# **THE LANDSCAPE CASE FOR FURTHER MITIGATION THROUGH THE CHILTERNS**

**EVIDENCE OF MRS BETTINA KIRKHAM DIPTP BLD CMLI  
FOR**

***BUCKINGHAMSHIRE COUNTY COUNCIL, THE CHILTERNS CONSERVATION BOARD AND CHILTERN  
DISTRICT, SUPPORTED BY AYLESBURY VALE AND WYCOMBE DISTRICT COUNCIL***

## 7. ANNIE BAILEY PH VENT SHAFT, SOUTH HEATH

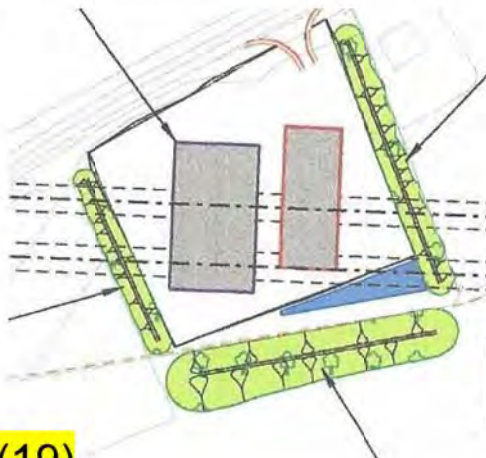
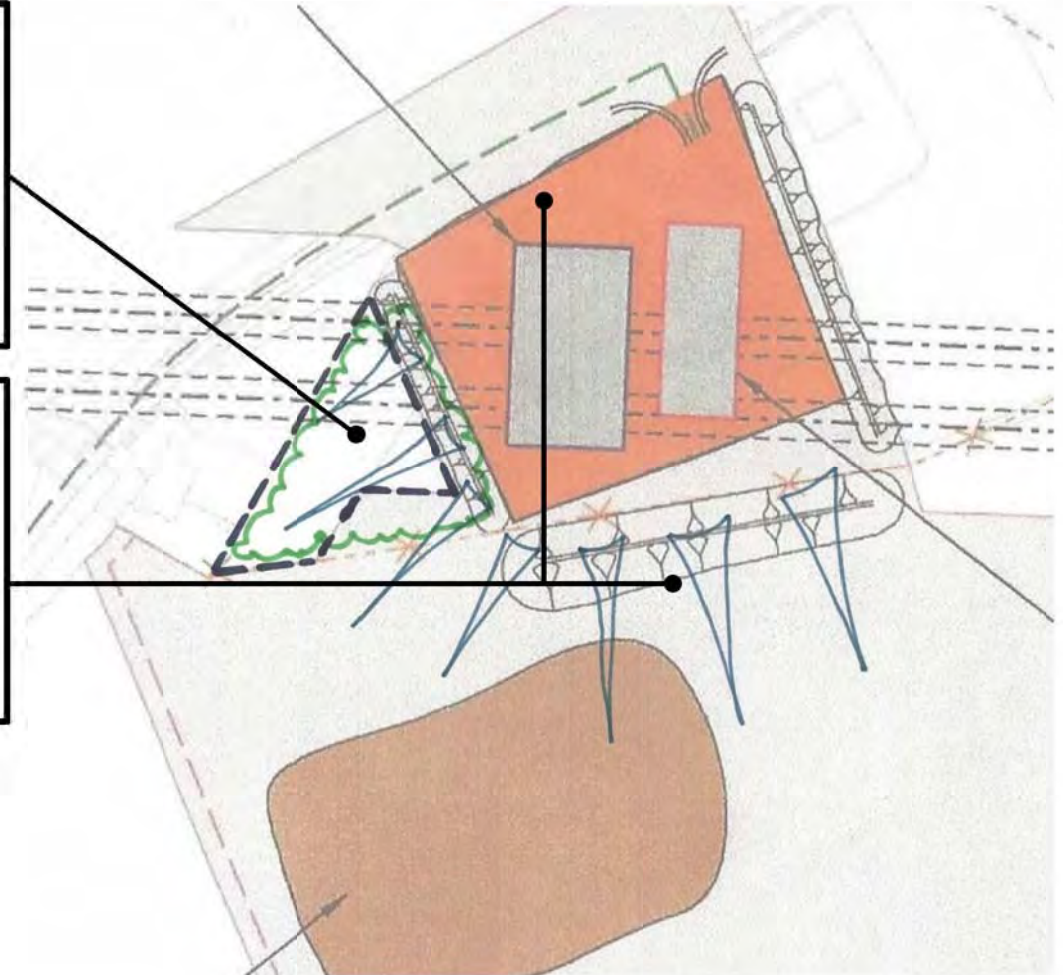
Small land take extension to field boundaries to grade bund into the plateau before planting to screen views from houses and Chesham Road

We suggest that the design is amended to ensure that the tree planting along Chesham Road is conserved and the bund graded gently southwards

## **Alternative construction route** at footpath GM1/12

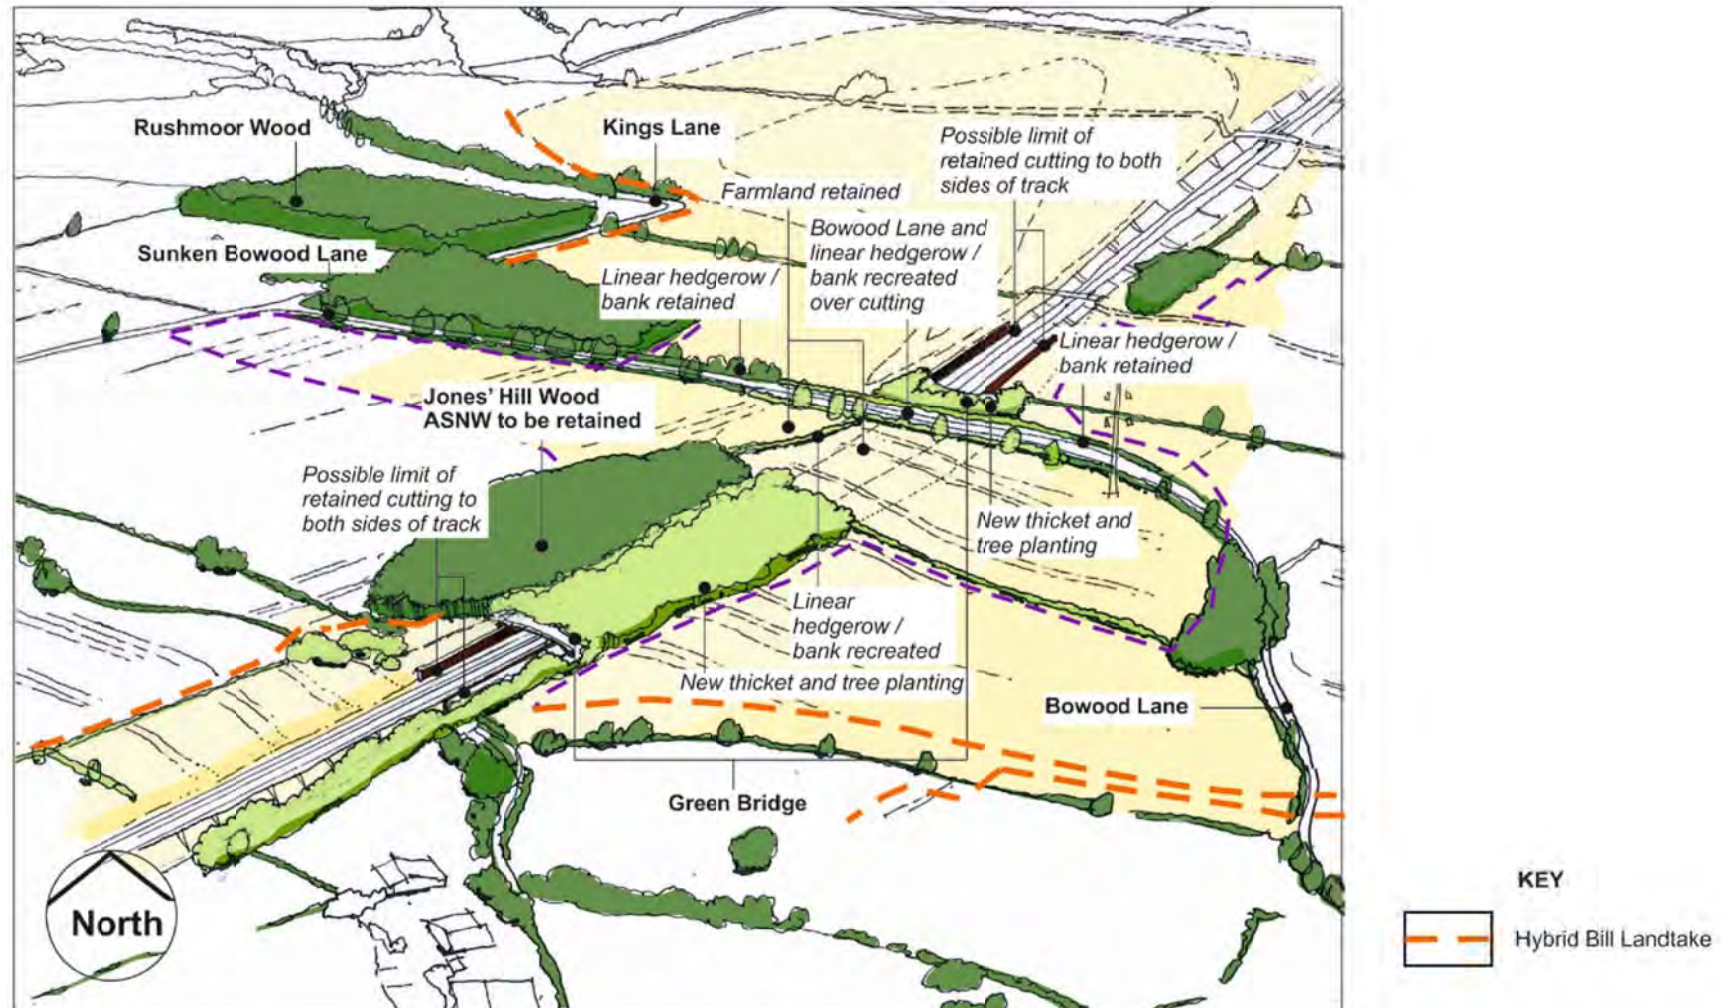
This would:

- Take advantage of an existing track up a shallow valley;
- Possibly reduce the need for cut and fill;
- Result in less harm to the landscape

# OUR ADDITIONAL LANDSCAPE MITIGATION – EXAMPLE OF A GREEN BRIDGE AND RETAINED CUTTING AT JONES' HILL WOOD ASNW

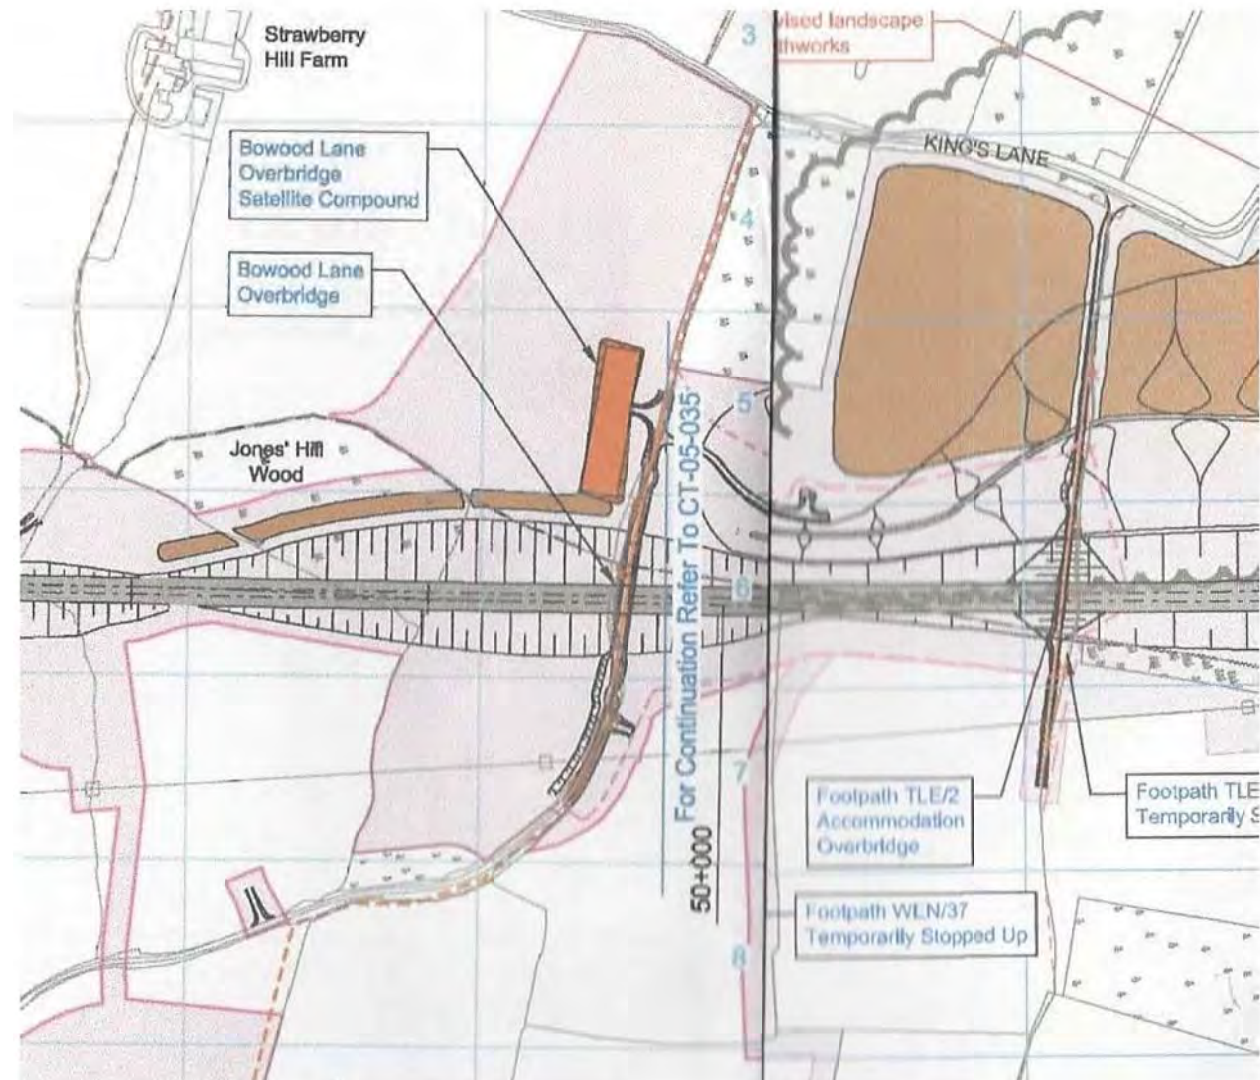
**THIS IS THE HYBRID  
BILL SCHEME  
DESIGN**

## A NARROW GREEN BRIDGE AND LOWER VERTICAL ALIGNMENT AT LIBERTY LANE

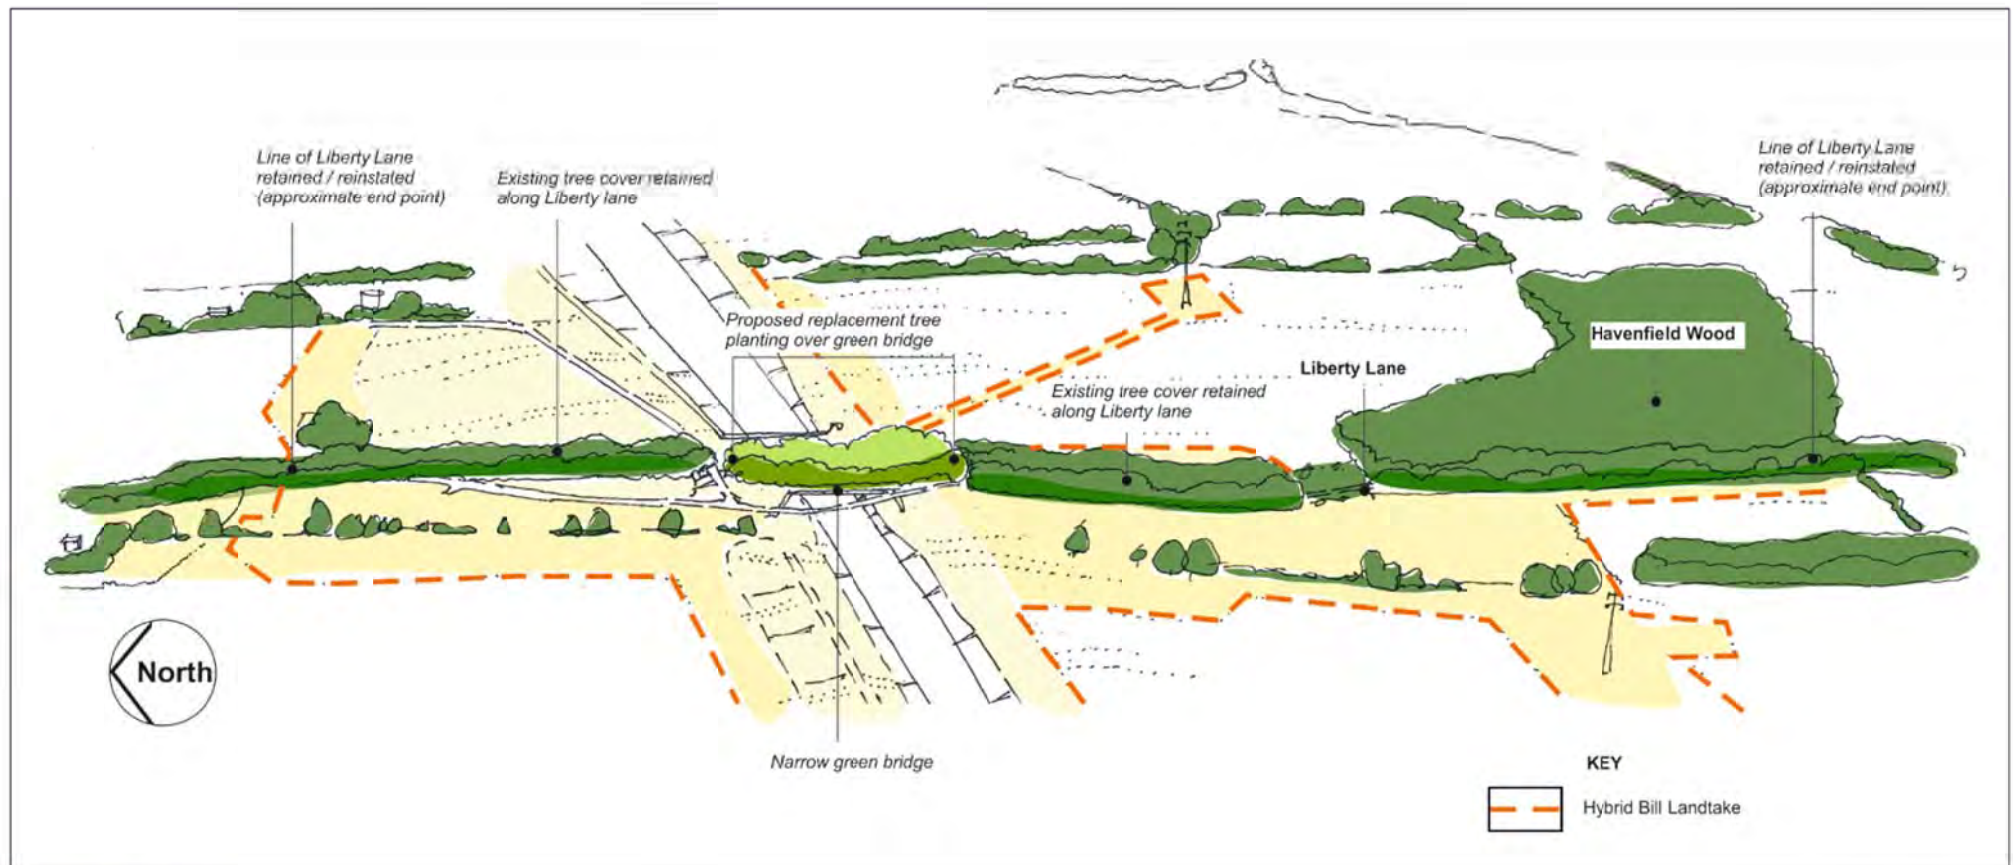
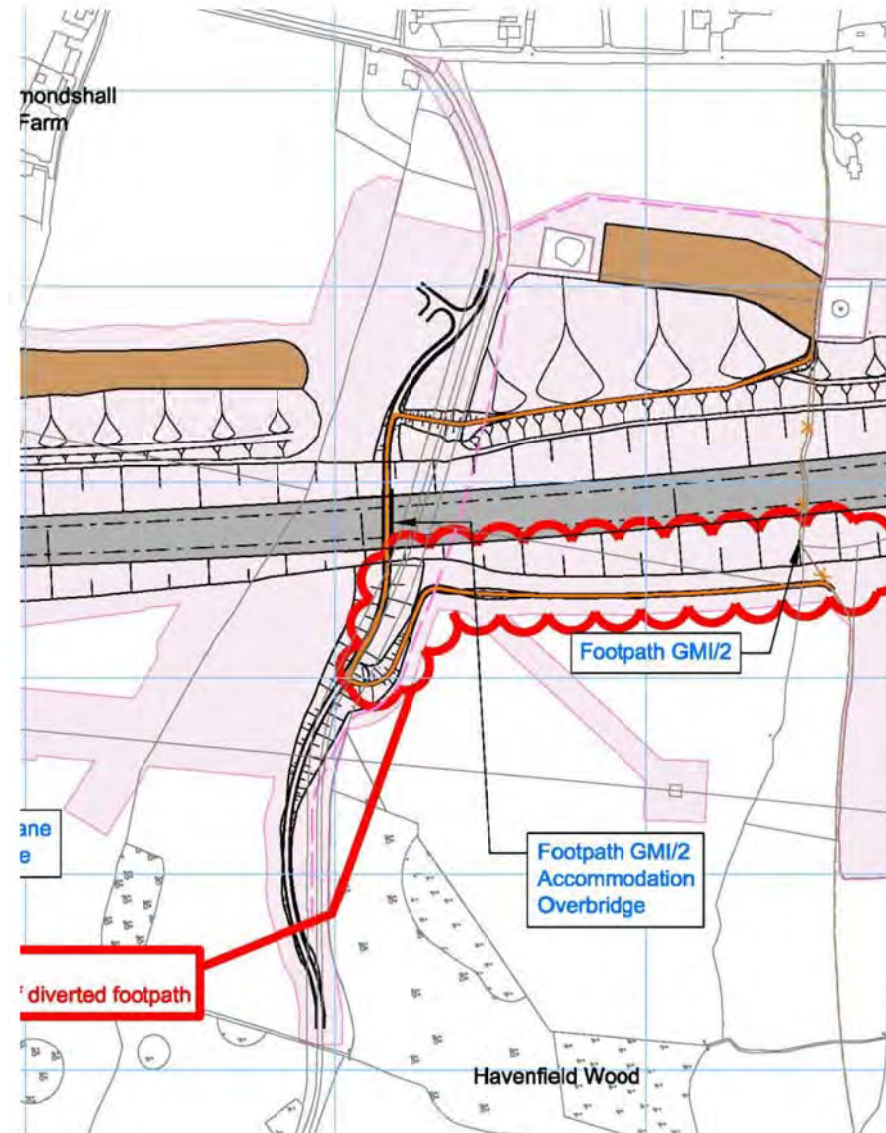
A **lower vertical alignment** from South Heath to north of Leather Lane within retained cuttings - therefore needing no more land take

- Significantly reduce visual impacts and the need for screen bunding;
- Allow for road and footpath crossings (eg Leather lane, Liberty Lane) at grade, minimising impacts;
- May reduce noise impacts and the need for attenuation;
- Reduce hunting habitats for barn owls and bats, avoiding potential conflicts with HS2

# OUR ADDITIONAL LANDSCAPE MITIGATION – EXAMPLE 3: GREEN BRIDGE AND RETAINED CUTTING AT GRIM'S DITCH SAM

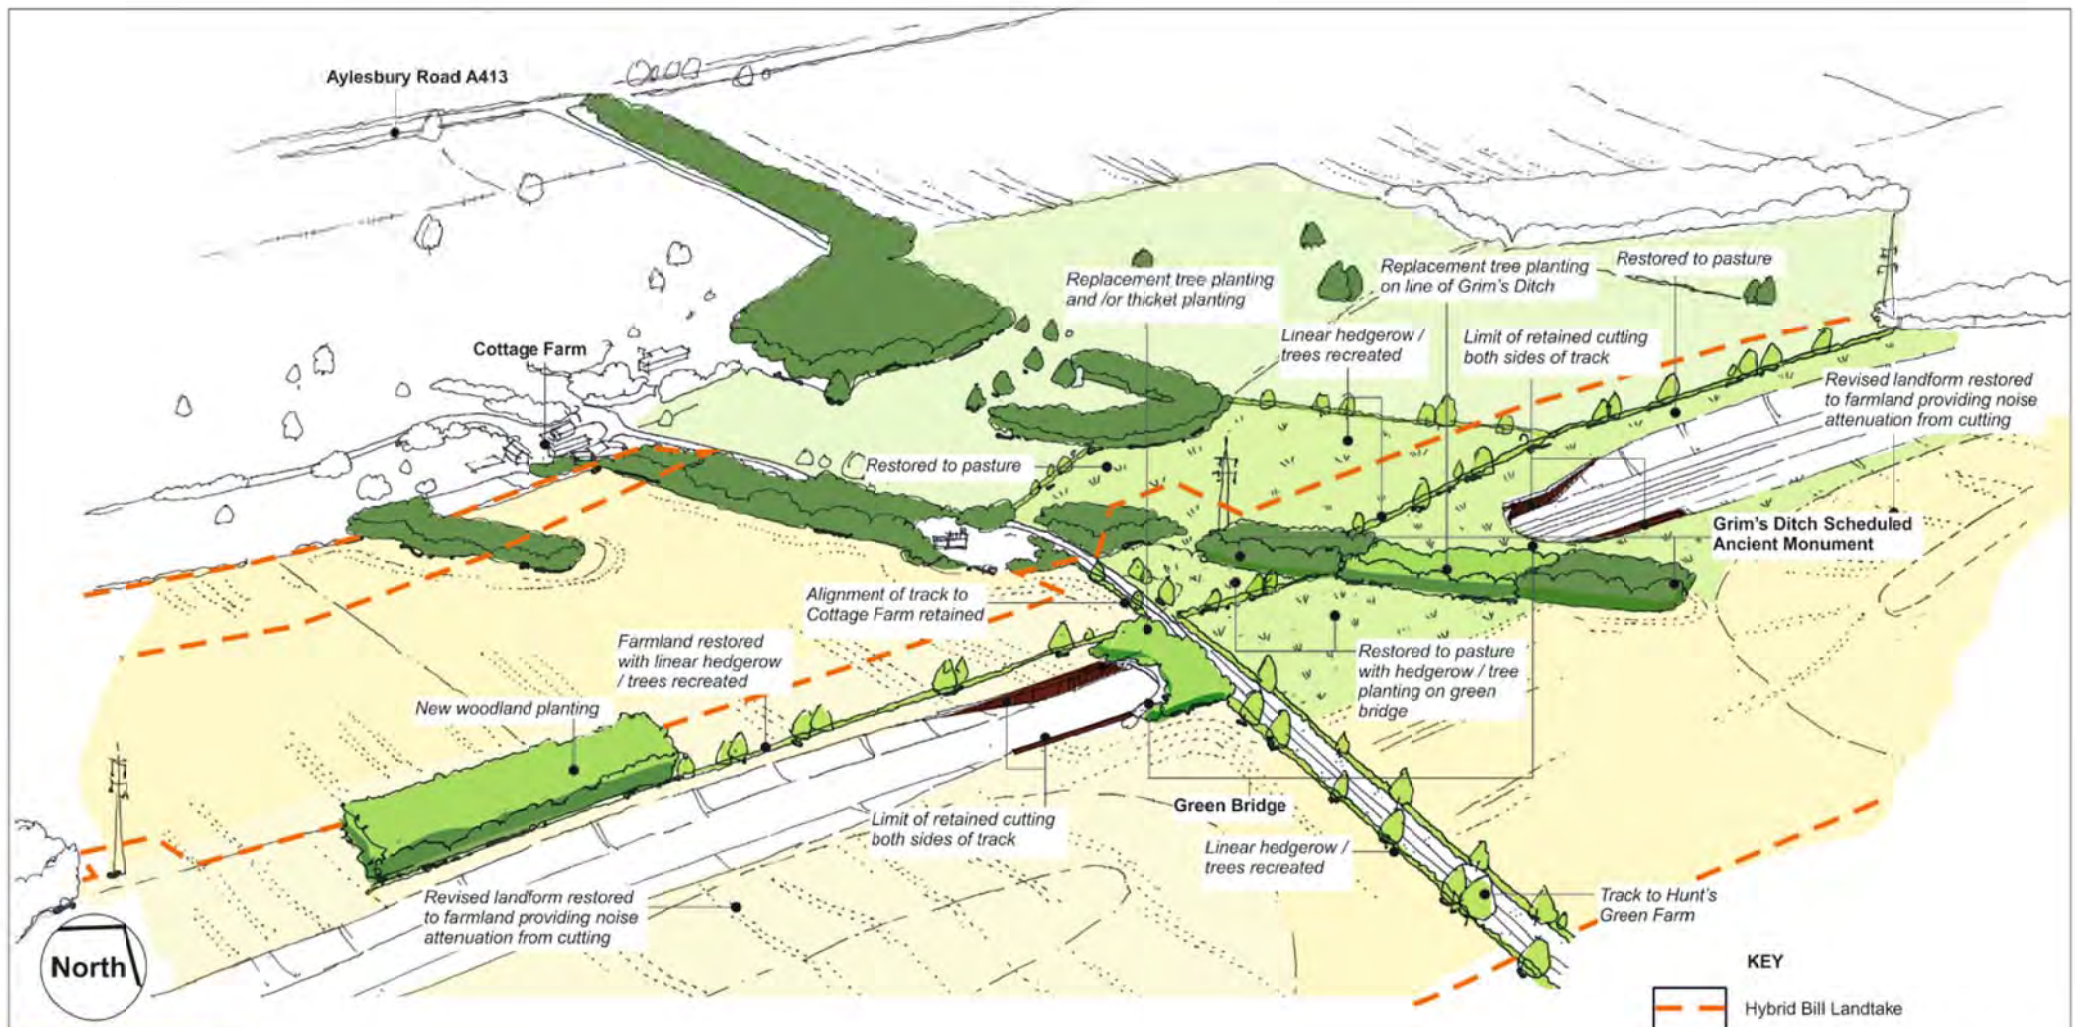
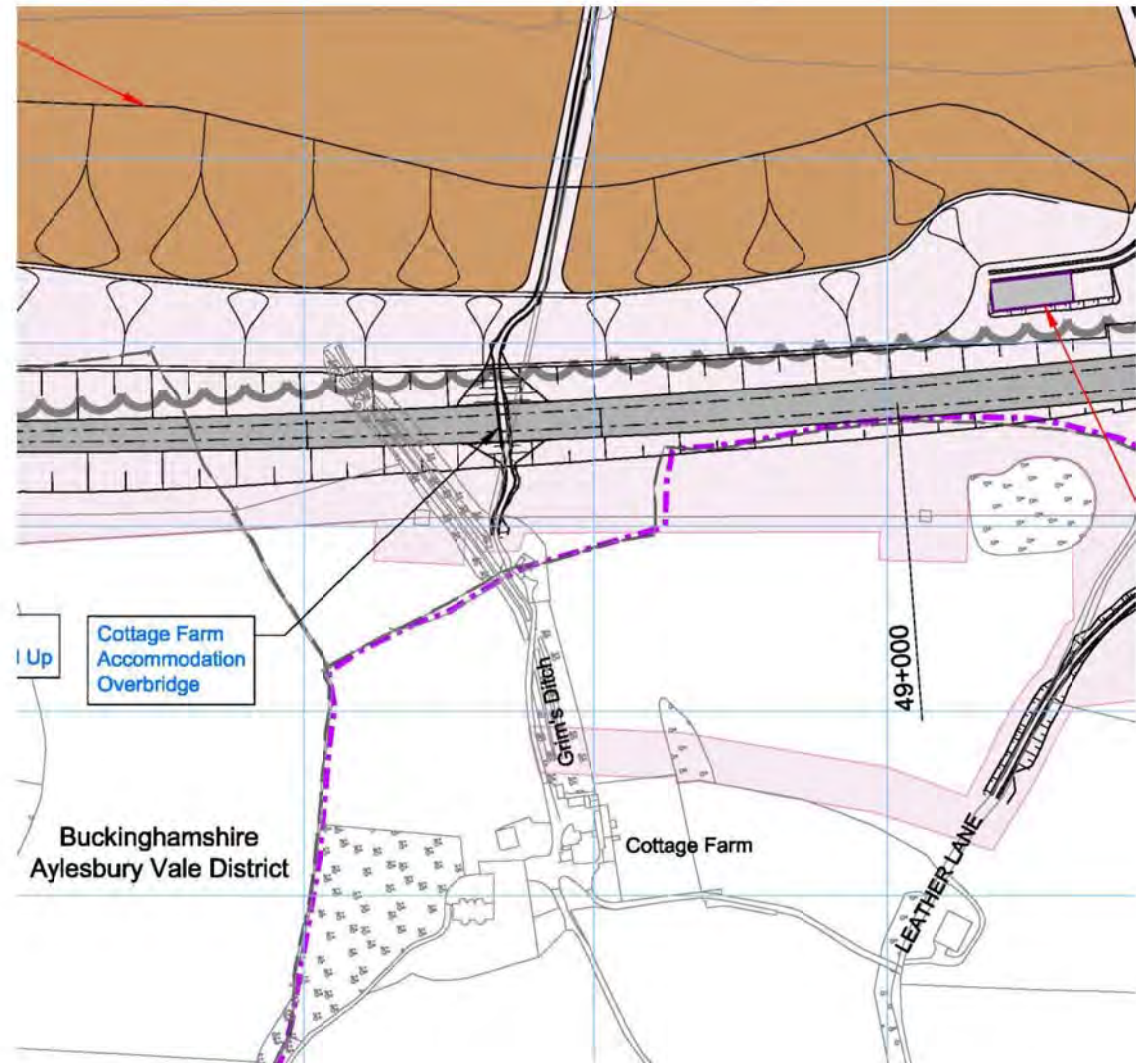
**Green bridges** at Liberty Lane, Bowood Lane, Leather Lane and Grim's Ditch SAM, Jones' Hill Wood ASNW

- Further protect these historic landscape assets by restoring connectivity;
- Provide wildlife corridors;
- Provide safe and pleasant crossings for walkers, riders and lane users;
- Enable greater restoration of farmland;
- Provide opportunities for landscape and ecological diversity
